# RENESAS TECHNICAL UPDATE

Product Category	MPU/MCU		Document No.	TN-SH7-A757A/E	Rev.	1.00
Title	SH7619 magnetics connection		Information Category	Technical Notification		
Applicable Product	R4S76190x125BG(V) R4S76191x125BGV (x=B/N/W/D)	Lot No.	Reference Document	SH7619 Group Hardware Manual ( REJ09B0237-0600 )		
		All lots

This document describes a supplement of the former technical update (Errata of guideline in SH7619 Ethernet Physical Layer:Document No. TN-SH7-A718A/E, Term of Figure 22.11).

Figure 1. The case with Belfuse(Magnetics is apart from RJ45 connector) [Partially cited from belfuse homepage]

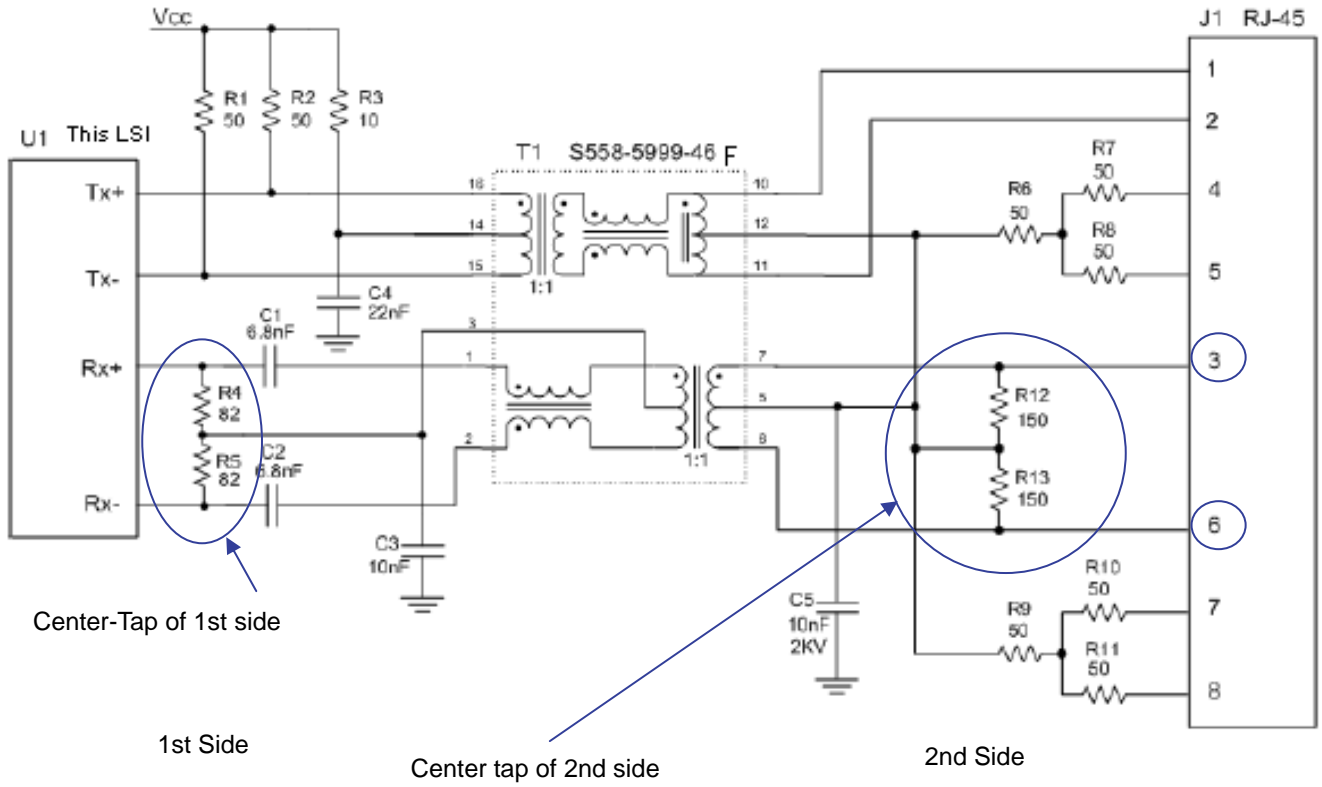
CASE1: 3<sup>rd</sup>&6<sup>th</sup> are connected to center-tap.

The 3<sup>rd</sup> pin(RD+) and 6<sup>th</sup> (RD-) of the cable are connected to center-tap through a resistor.

In this case, please make the total resistor from resistors on 1<sup>st</sup> and 2<sup>nd</sup> sides, 50ohm.

Figure 1 shows  $R_{total} = 53ohm$ . (approximately 53ohm) from the  $1/R_{total} = 1/82 + 1/150$ .

Figure 2. The case with TDK TLA-6T718(Magnetics is built in RJ45 connector) [Partially cited from TDK Homepage]

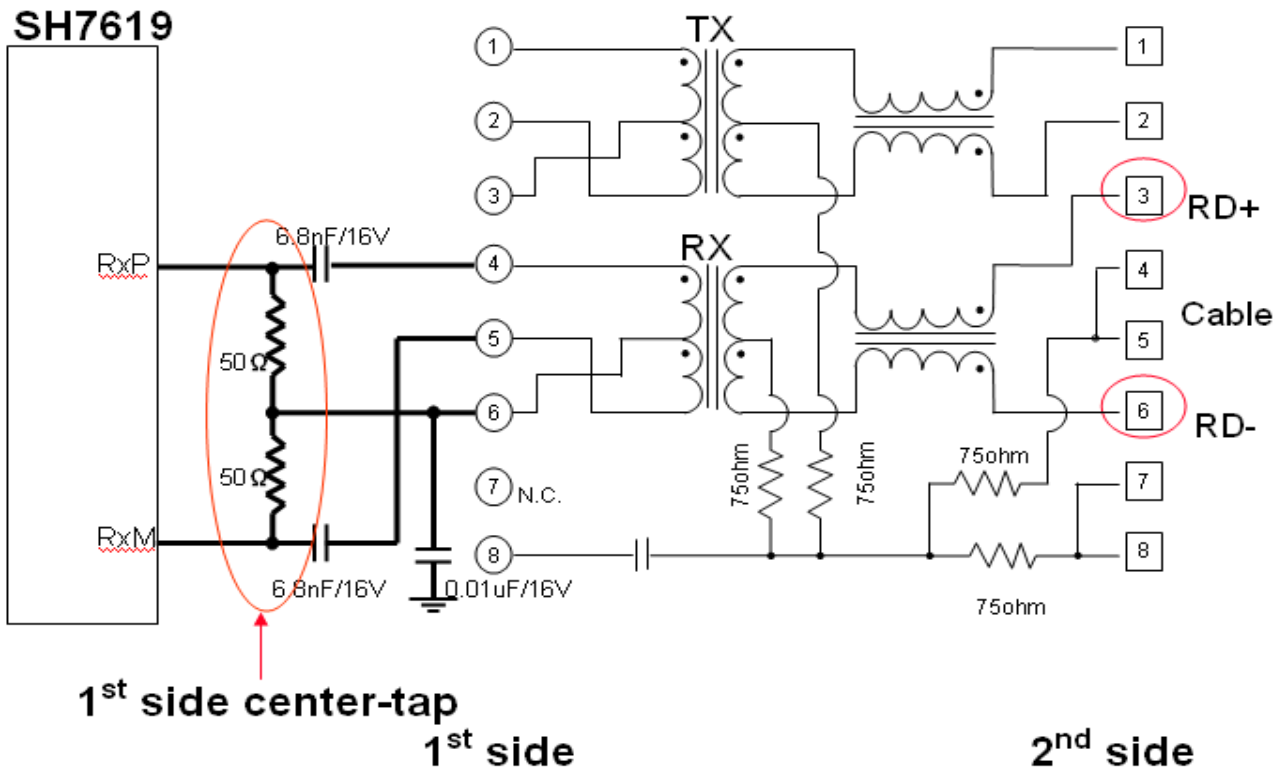
CASE2: 3<sup>rd</sup>&6<sup>th</sup> are NOT connected to center-tap.

The 3<sup>rd</sup> pin(RD+) and 6<sup>th</sup> (RD-) of the RJ45 are connected to center-tap through a resistor.

In this case, please make the resistor of 1<sup>st</sup> side, 50ohm.
